**AP1000 CORE REFERENCE REPORT**  
**DCD (Rev. 19) Change Road Map**

Change No.	Chapter 15 Section 15.5	Change Summary Description
[15.5-1]	15.5.1, Inadvertent Operation of the CMT During Power Operation	<p>The following changes were incorporated in the updated analysis: increased <math>F_{\Delta H}</math> limit (1.65 to 1.72), addition of the flow skirt, increased lower core support plate flow hole size, increased pressurizer volume, increased RV diameter for the neutron pad addition, containment backpressure effects on PRHR heat transfer, increased rod drop time for the safety analysis and the updated valve, nozzle and piping pressure loss coefficients.</p> <p>Editorial changes were made to the inadvertent CMT analyses to identify an operator action to open the safety related reactor vessel head vent to prevent filling the reactor coolant system water solid.</p>
[15.5-2]	15.5.2, CVS Malfunction that Increases Reactor Coolant Inventory	<p>The following changes were incorporated in the updated analysis: increased <math>F_{\Delta H}</math> limit (1.65 to 1.72), addition of the flow skirt, increased lower core support plate flow hole size, increased pressurizer volume, increased RV

Figure 15.5.1-1

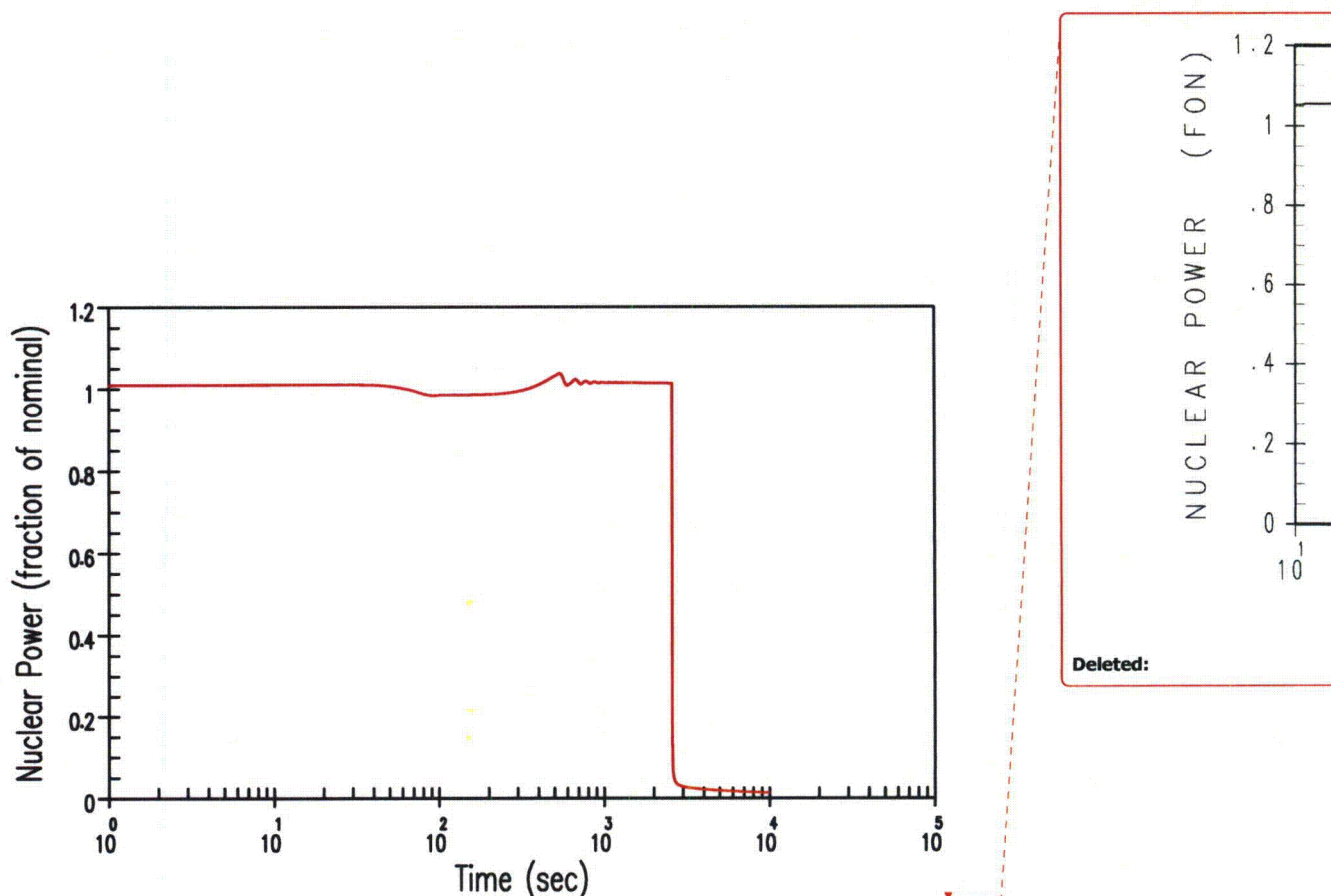
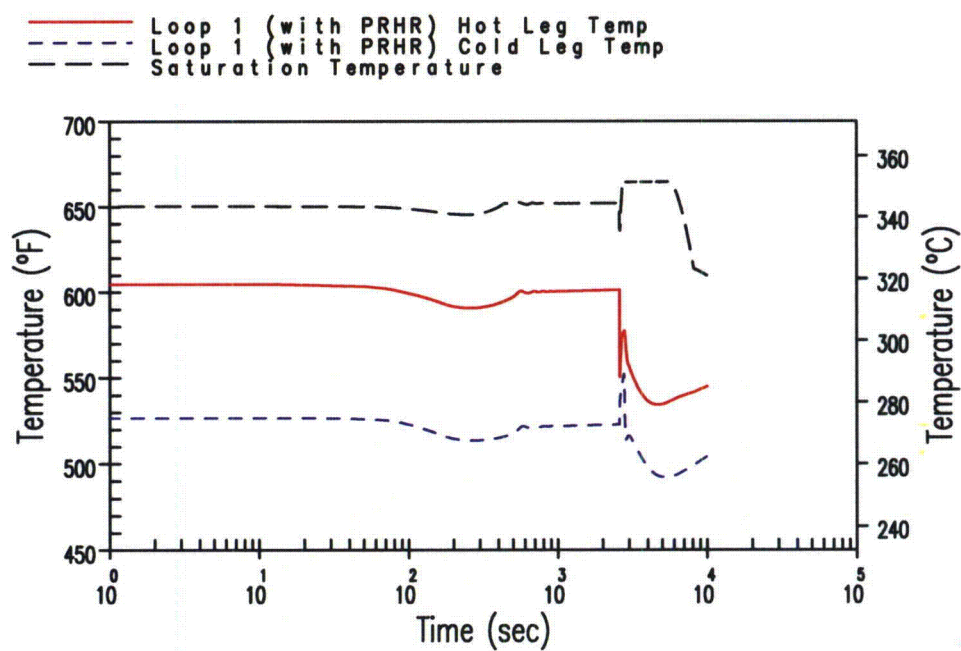
Comment [B1]: [15.5-1]
